# MEMORANDUM

**SUBJECT:** Consideration of a Landmark Alteration Certificate application to restore the existing house, demolish a non-historic addition on the contributing house and in its place construct a new addition, and to demolish a non-contributing 846 sq. ft. garage and its place construct a 521 sq. ft. two-car garage, all at 603 Highland Ave. in the Mapleton Hill Historic District, per section 9-11-18 of the Boulder Revised Code 1981 (HIS2014-00345).

1. Site: 603 Highland Ave.
2. Zoning: RL-1 (Residential-Low 1)
3. Lot size: 10,465 sq. ft.
4. Existing House: 5,216 sq. ft.
5. Proposed remodeled house: 4,617 sq. ft.
6. Existing Garage: 846 sq. ft.
7. Proposed Garage: 521 sq. ft.
8. Owner: Beth and Will Bashan
9. Applicant: Christopher Melton
10. Date of Construction: 1890

Figure 14. Proposed Site Plan. Not to scale.

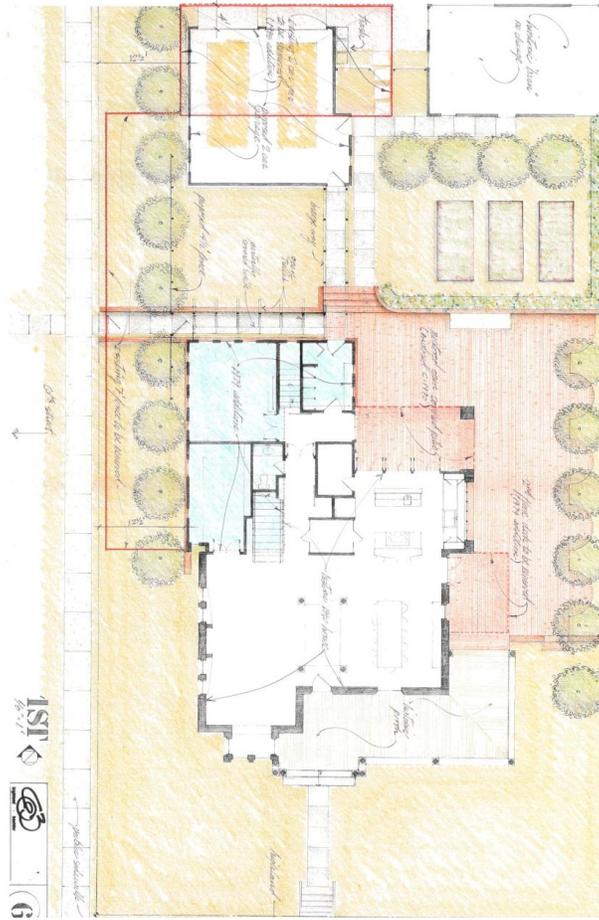
Plans show the new two-story addition to feature flat roof, wood shingle siding double-hung and fixed casement windows and a slightly cantilevered second-story at the north end. The existing addition is highly visible from both Highland Ave. and 6<sup>th</sup> St. and the proposed addition will also have high visibility from these public ways.

| .7  | <i>Preserve a backyard area between the house and the garage, maintaining the general proportion of built mass to open space found within the area</i> | Proposal shows floor area reduction on property from .49 to .43. Distance between house and existing non-historic garage is 30 ft. Distance between proposed garage and house shown reduced to 20 ft. and buildings linked by breezeway. Space between historic and proposed garage increased from 5 ft. to 14 ft. Consider reducing length of new garage and eliminate breezeway. Review at the Ldrc. | <b>Maybe</b> |

| .4                             | <i>Preserve a backyard area between the house and the accessory buildings, maintaining the general proportion of built mass to open space found within the area.</i>        | Construction of proposed two-car garage will slightly increase the footprint of buildings on the property and proportion of built mass to open space of the property or streetscape. Distance between existing garage and house approximately 30 ft.; Distance between proposed garage and house is 20 ft. Consider reducing size of new garage to one-car garage. Review at Ldrc. | <b>No</b>    |

3. The new garage shall be reduced in size to a one and one-half car garage that is set back at least two feet from the north face of the historic barn and at least 25 feet shall be maintained between the north wall of the new addition and south wall of the new garage.

*Figure 20. Proposed East Elevation*

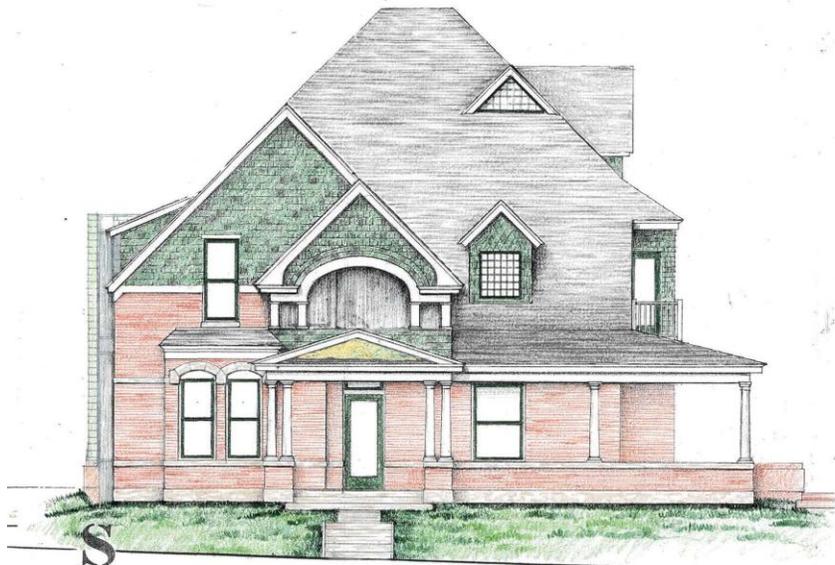
The east elevation of the proposed addition is shown to be sided in wood shingle and feature two casement windows first floor and a single double-hung window on the upper-story wall. Changes to the east face of the main house include restoring the first floor porch, replacement and widening of a first floor door and changing a window opening to a French door to provide access to the second story balcony.

2. The dimension of door opening on the first floor of the east elevation shall not be changed and the existing south door to the east balcony shall be preserved;

Figure 23. Proposed North Elevation, New Garage at right.

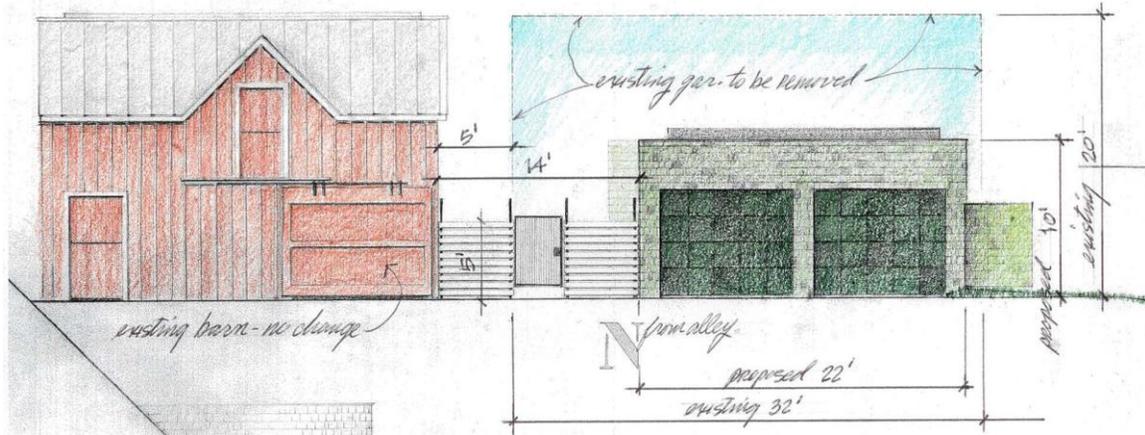
The west wall of the new garage is shown to be located 12 ½ ft. from the west property line and 4 ft. from the north (alley) property line). Plans show a 14 ft. space between the historic barn and the proposed garage where 5 ft. now exists. The proposed garage is shown to be linked to the proposed addition on the main house by way of an open breezeway.

| .2                              | <i>New garages and accessory buildings should generally be located at the rear of the lot, respecting the traditional relationship of such buildings to the primary structure and the site.</i>  | Proposed new garage is shown to be located at the rear of the property, but connected to the main house by way of a breezeway. Consider removing breezeway element – review at Ldrc.                                  | <b>Maybe</b>            |

Figure 25. Proposed East Elevation, Garage.

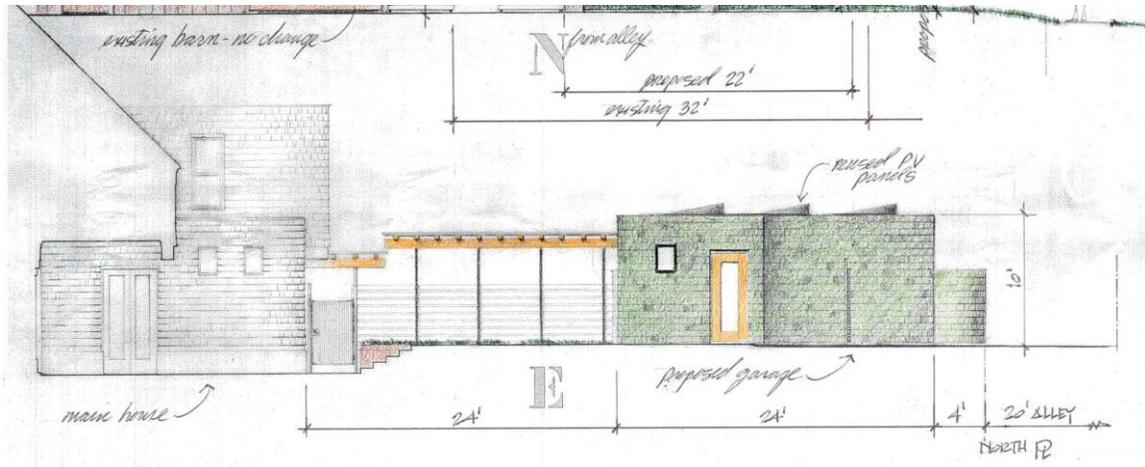
The south elevation is shown to have a single-light pedestrian door with a bracket roof above the entrance. The east elevation is shown to have a pedestrian door and a small casement window. A 6 ft. wall is shown to wrap the north and west elevations of the garage, extending 4 ft. from the west wall. Photovoltaic panels are shown to be located on the roof of the garage.

| .5                             | <i>New accessory buildings should take design cues from the primary building on the property, but be subordinate to it in terms of size and massing.</i>                    | Proposed design relates to proposed flat roof addition to house. Proposed garage is subordinate to house and historic accessory in terms of mass and height.   | <b>Maybe</b> |

Figure 27. Proposed fence detail.

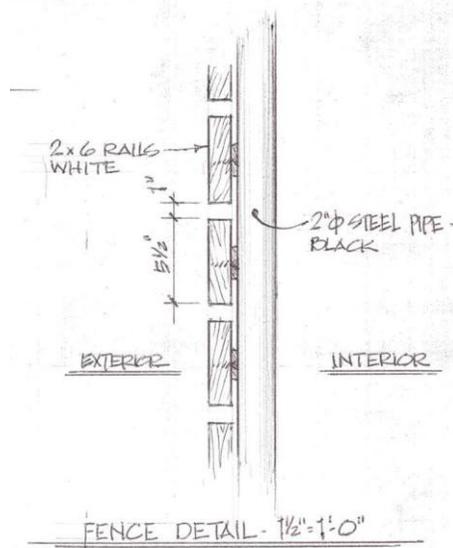
A fence is shown to be located along the west property line, extending from the wall of the proposed garage to the rear of the proposed addition, terminating at a gate and continuing approximately 10 ft. south from the southwest corner of the addition. The wood fence is shown to be set back 12 ft. from the sidewalk and measure 4 ½ ft. in height with 2" black steel pipe and the rails measuring 2" by 6" with 1" spacing. The fence is shown to be painted white.

| .7       | <i>The finish side of the fence should face toward the street or sidewalk.</i>   | This detail unclear from plans. Confirm at Ldrc.  | <b>Maybe</b>                     |
